## Comment Resolution Status

Document: T10/01-328r8

To: T10 Committee Membership  
From: Cris Simpson, Intel Corporation  
Subject: Response to T10 Letter Ballot comments on SRP

Figure 0.1 - IB I/O unit example

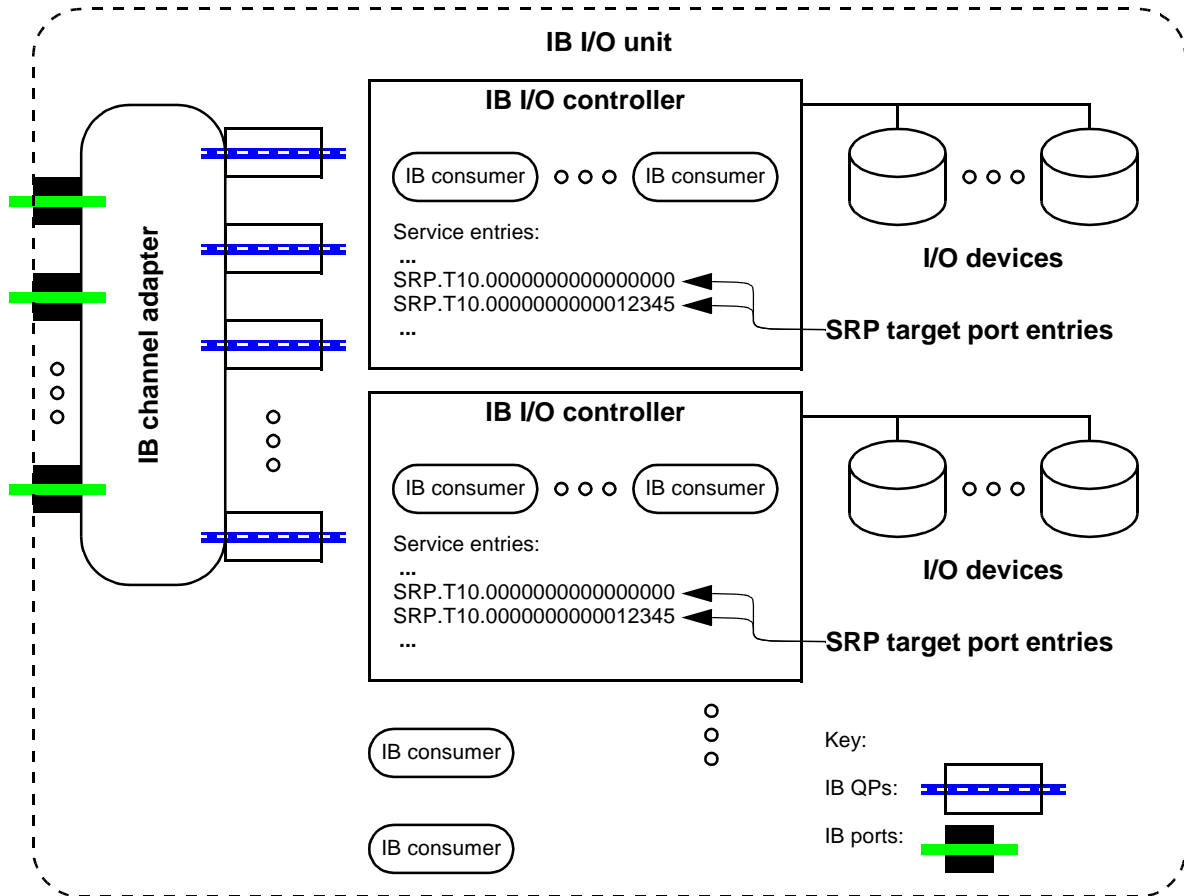
Figure B.3's equating of 'SRP Target Ports' with 'IB consumers' is problematic. A 'target port' is a sort of service access point---somewhere where interested parties initially go to obtain service, but without any implication that that's where the service is actually provided. (In IB, it's the Connection Manager that receives the initial connection request, interprets the ServiceID contained therein, and performs some magic that results in the instantiation of a QP bound to some entity that actually provides the target services). This target-services-providing entity fits the definition of 'IB consumer'. But the mapping of ServiceIDs-cum-SRP target ports onto such entities is clearly a matter of implementation, and could be one-to-many, many-to-one, or many-to-many Suggested Solution: One possibility: to the left of the IB Consumers show a table/list of service IDs within each IB I/O unit and label these entries as SRP Target Ports; use arrows to show a mapping from the entries to the IB Consumers, with e.g. one Consumer mapped to two IDs and another mapped to one ID to show that the mappings are not always 1 to 1. A further refinement might be to use another set of arrow between the Consumers and the QPs to show that the this mapping is also not 1 to 1

Notes from 28 Nov 2001 teleconference: show service entries in figures B.2 and B.3, in accompanying text explain that each service entry identifies an SRP target port.

This comment is correct, but it's not immediately obvious how to incorporate it into a legible diagram. Note the further complication introduced by connection redirection. The IB consumer (IB QP and the software, etc. behind it) may be in an unrelated device / node / whatever, it need not be the same channel adapter or even an I/O unit. The sole purpose of the I/O unit and I/O controller is to obtain a service ID, connecting to that service ID may lead somewhere else altogether.

The following is an attempt at a modified figure B.2 and the text describing service entries that identify SRP target ports
